INDEX			
CIRCULARS			
SL.NO.	DETAILS OF CIRCULAR	DATED	PAGE NO.
1	ACCEPTANCE OF BANK GUARANTEES.	08.04.2008	2
2	VENDOR LIST FOR APPROVED MAKE OF MATERIAL & EQUIPMENT FOR RO's.	13.11.2008	4
3	GUIDELINES FOR LABORATORIES FOR TESTING OF CONSTRUCTION MATERIAL	18.11.2008	5
4	PREVENTION OF FIRE ACCIDENTS AT RETAIL OUTLETS	24.11.2008	6
5	DRAWINGS FOR RVI WORKS	19.12.2008	8
6	ISSUANCE OF WORK ORDERS	24.12.2008	51
7	EFFECT OF PUTTING A PARTY ON HOLIDAY LIST - ADDITIONAL SITUATIONS	20.02.2009	52
8	REDUCTION IN SERVICE TAX	24.02.2009	54
9	PROVISION OF SADDLE PLATE FOR PIPELINE	10.03.2009	55
10	PREPERATION OF FINAL BILLS & CLOSURE OF WORK ORDERS	13.03.2009	59
11	SEQUENCE ON DISPLAY PANEL OF MAIN SIGN POLE	09.03.2009	60
12	STANDARIZATION OF SPECIFICATION FOR SEAL ON FR TANKS	15.04.2009	61
13	FIRE SCREEN WALL	17.04.2009	65
14	ENGRAVING THE NAMES OF PROJECT IN CHARGE AT SITE	21.04.2009	66
15	FINAL APPROVAL FOR PROVISION OF HIGH MAST SIGNAGE 17M/22M HIGH	18.05.2009	67

16	STANDARD DRAWINGS OF 20 & 70 KL TANKS ON AVIATION SERVICE	19.05.2009	70
17	FLEXIBLE PIPING BY OILCO SERVICES(NOT TO USE UPP F.P. OF OILCO)	11.06.2009	78
18	FLEXIBLE PIPING BY L&T(NOT TO USE KPS F.P. OF L&T)	15.06.2009	80
19	DELET

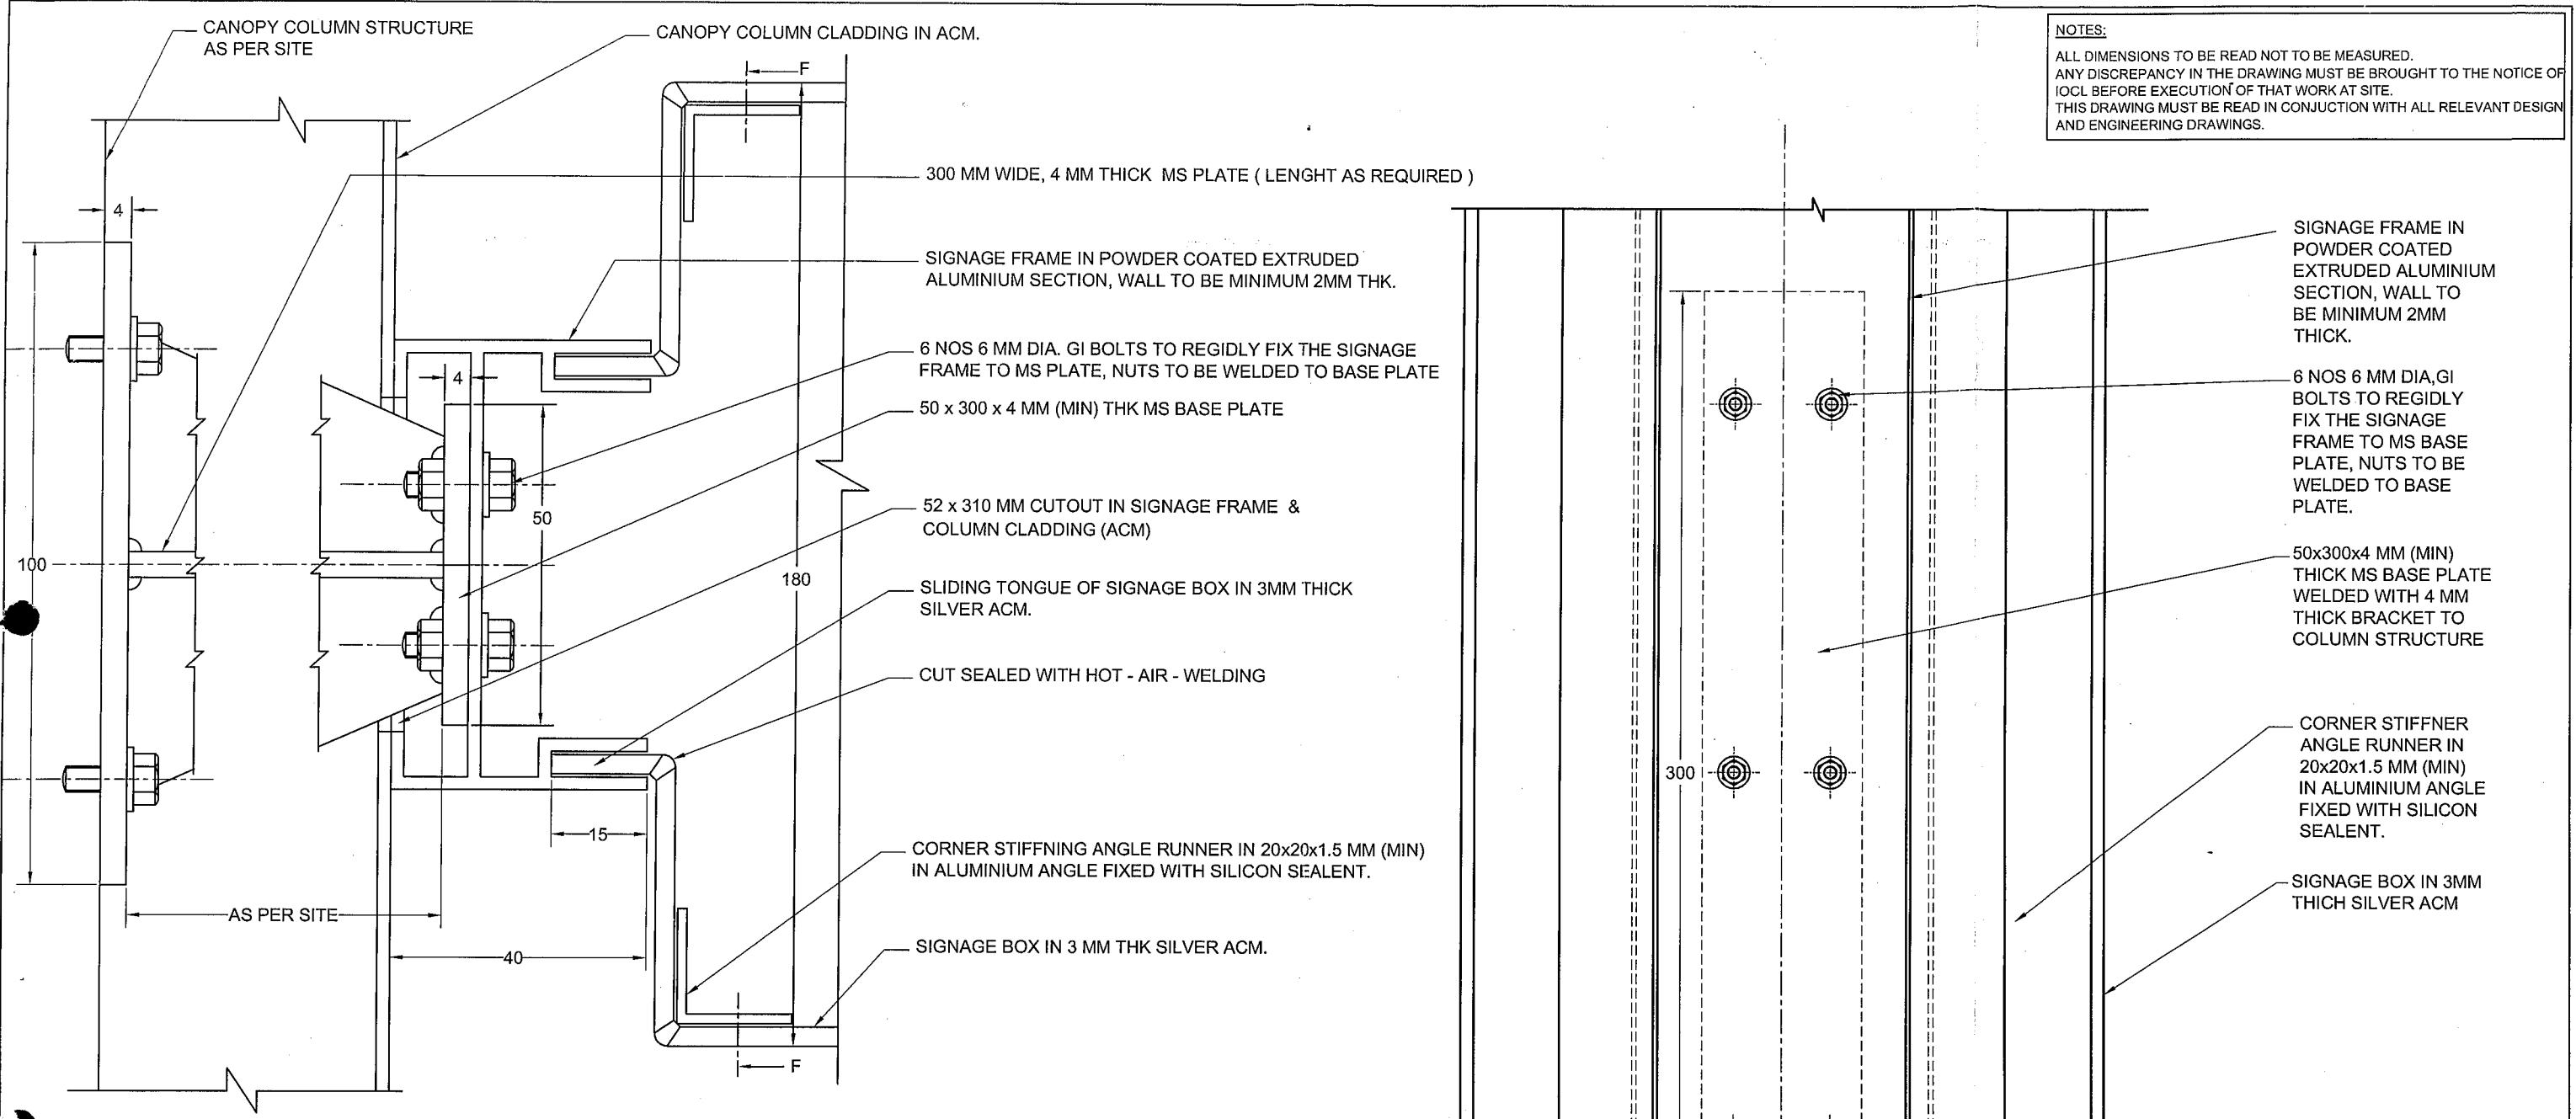
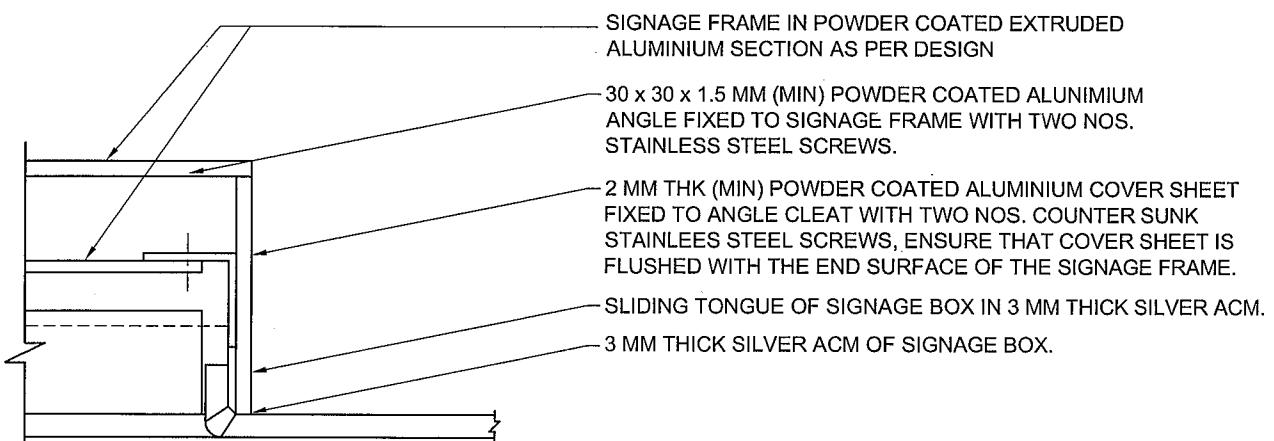
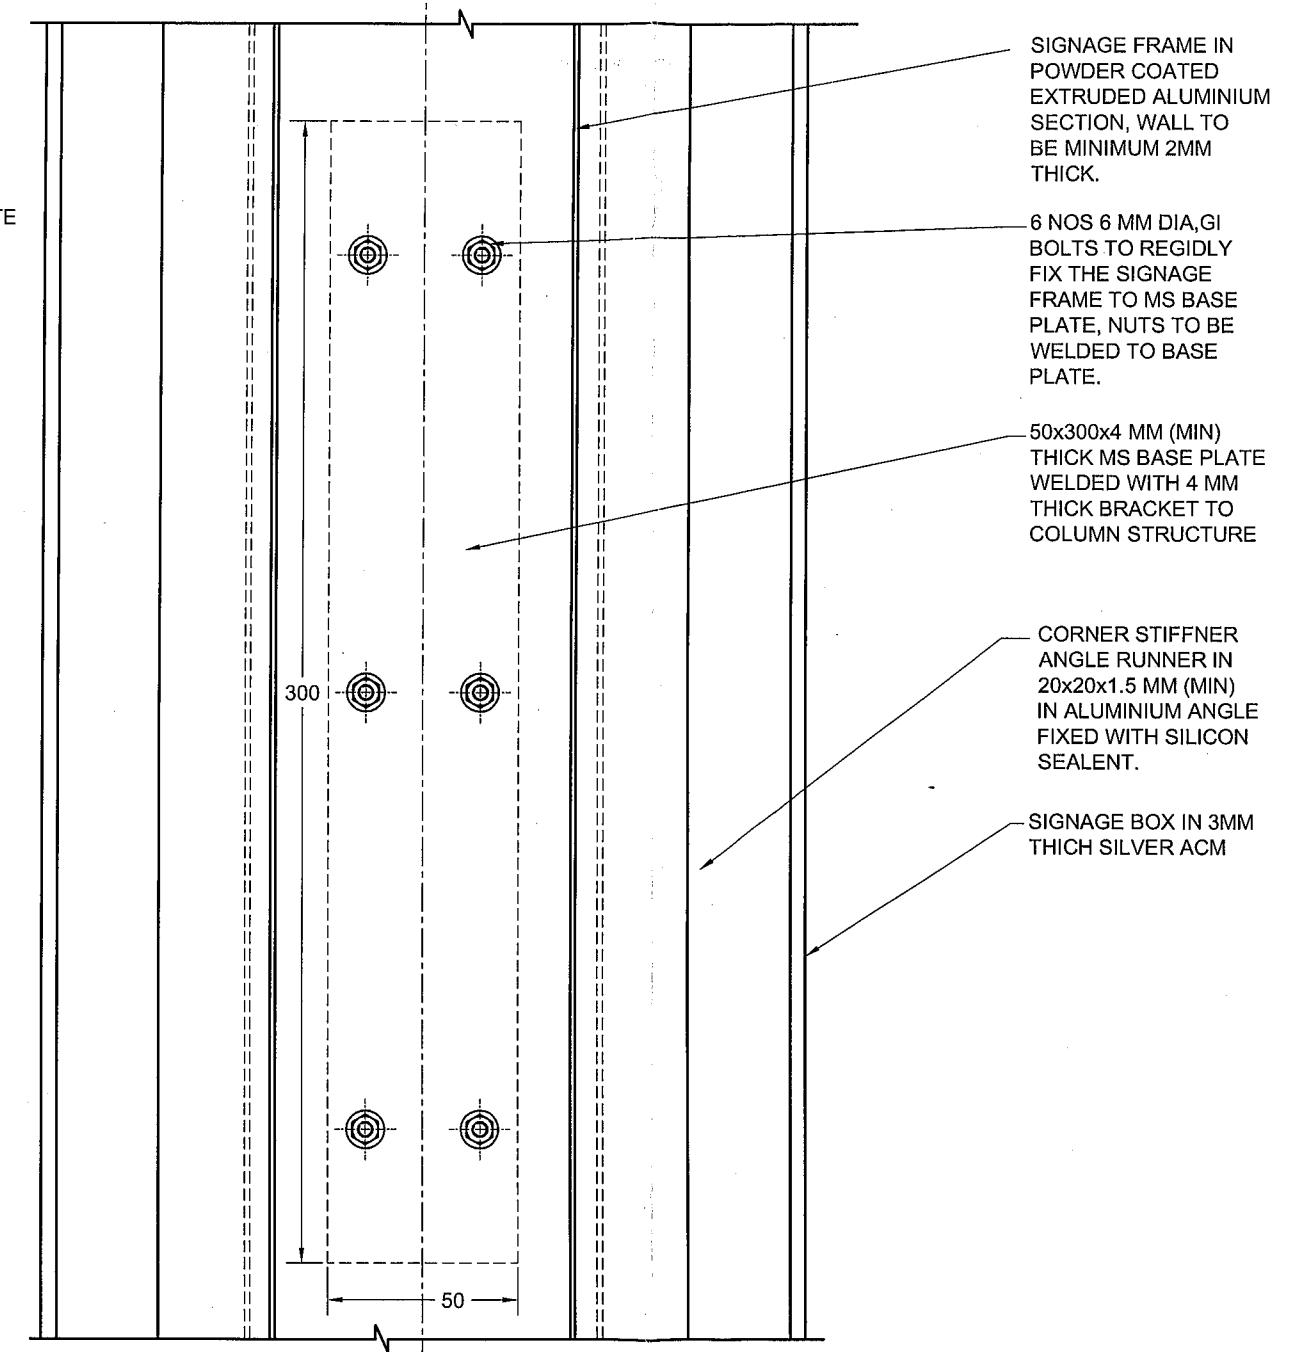
• ALL DIMENTION IN MM	
• DO NOT SCALE	
• IF IN DOUBT, PLEASE ASK	
1	DETAILS OF BRACKET TO COLUMN STRUCTURE REVISED
S.NO	DATE
REVISION	REVISION DETAILS
INDIAN OIL CORPORATION LIMITED 'INDIANOIL BHAVAN' G-9, ALI YAVER JUNG MARG, BANDRA (EAST), MUMBAI - 400 051	
RVI ELEMENTS	
TITLE: SPREADER FIXING DETAIL CANOPY CLADDING FIXING DETAILS	
CHKD. BY:	DATE: 26.03.2008
APPD. BY:	DRN. BY: SHREE ENGINEERS
DRAWING NO: IOC-RVISS2-DD-AR-003-R01	
SCALE: --	
SHEET: -

TYPICAL DETAILS OF PEDESTALS

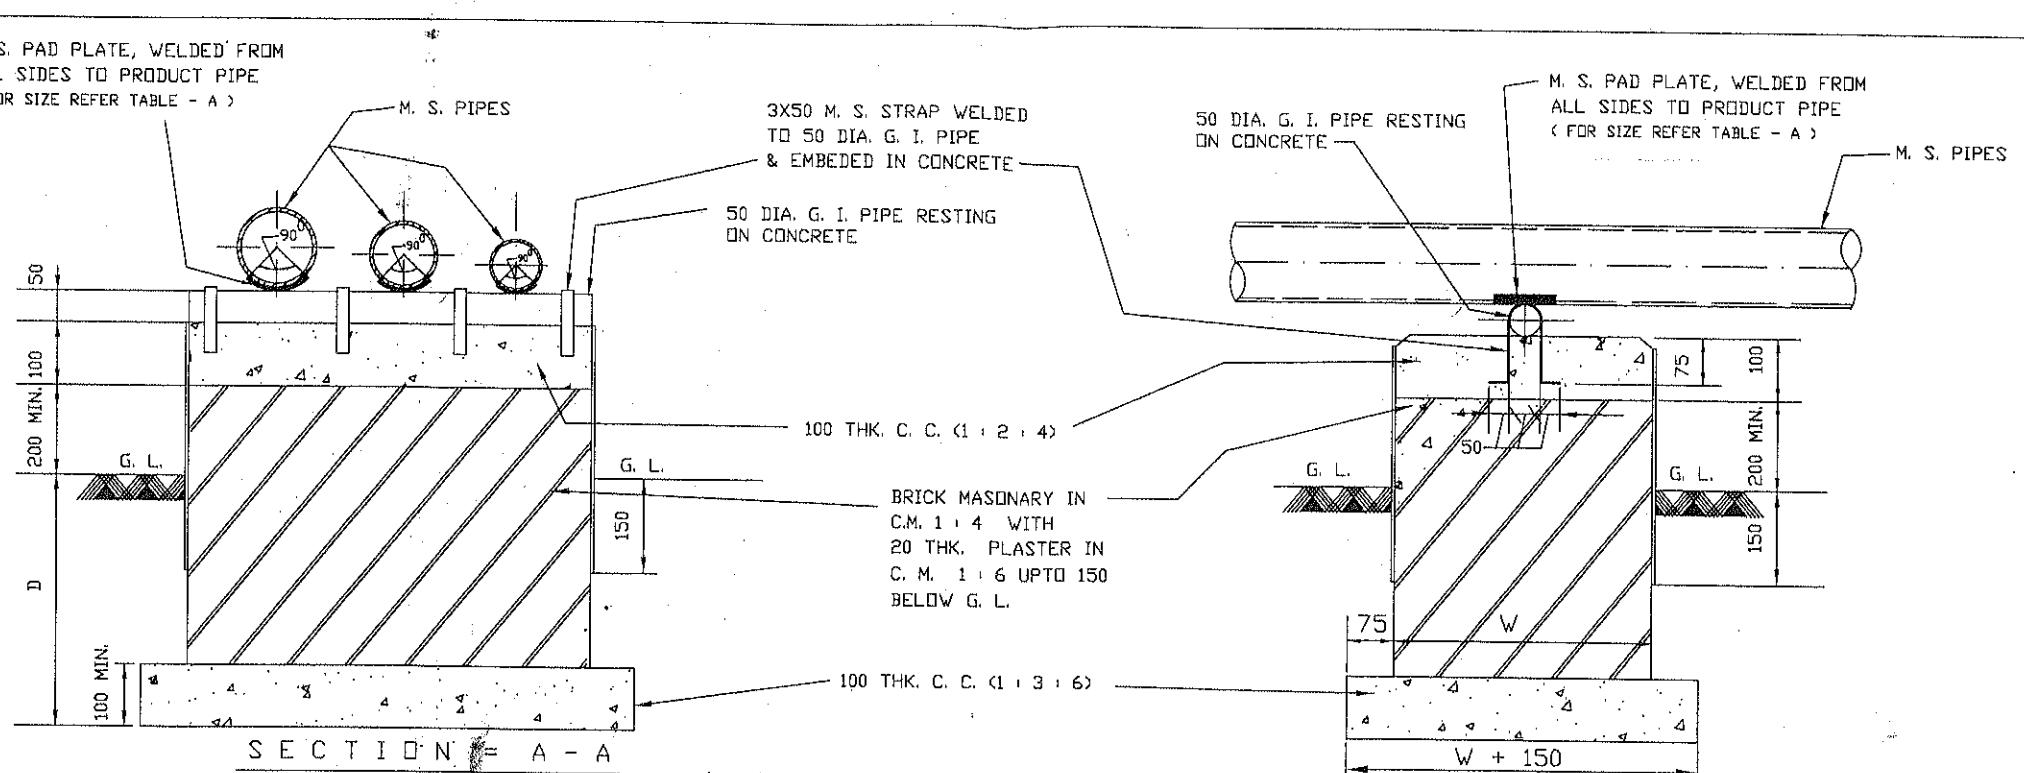
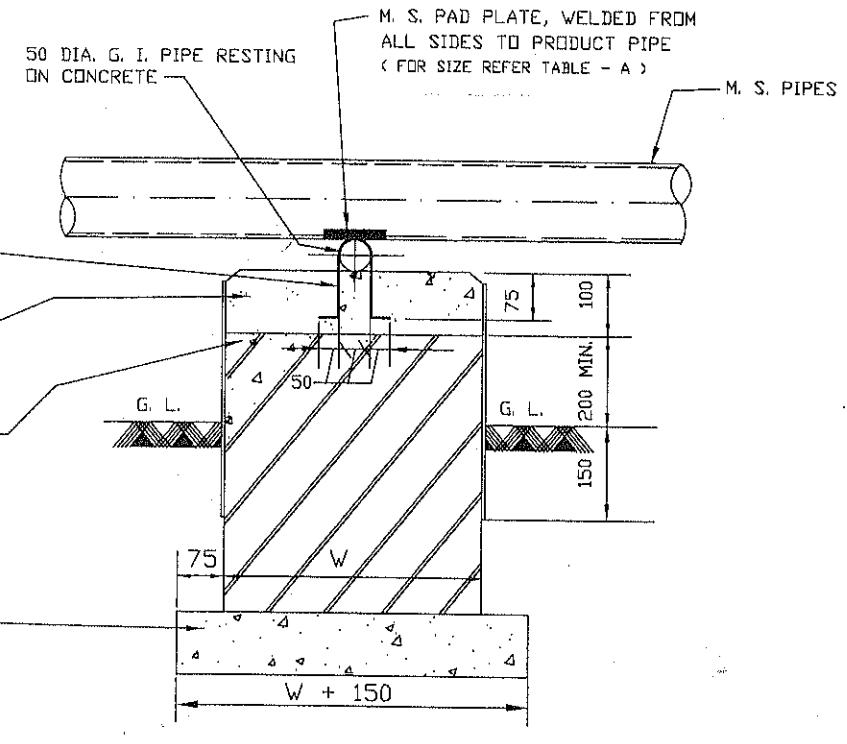
1. Presently while laying product / fire hydrant pipelines during execution of new projects or old pipeline replacement works pipes are made to rest on GI pipe of 50 mm Ø as shown in Typical Drawing for pipeline pedestals in Engineering Manual Vol. 6 {Drawings No. 428-1/2 (page-127) & No. 428-2/2 (page-128)}.

3. To avoid above mentioned problem and enhance the life of pipelines it is decided to provide reinforcement on the pipelines by way of welding a saddle / pad plates at the point of contact. Considering the pipes of various diameters commonly used in our locations following size of saddle plates are to be provided:

6. Drawings (No. IOCL/HO/M&I/SK - 1 & IOCL/HO/M&I/SK – 2) showing the provision of saddle / pad plate are enclosed herewith. (Annexure I). GM (E) may get the relevant drawing in Engineering Manual Vol. No. 6 suitably amended.
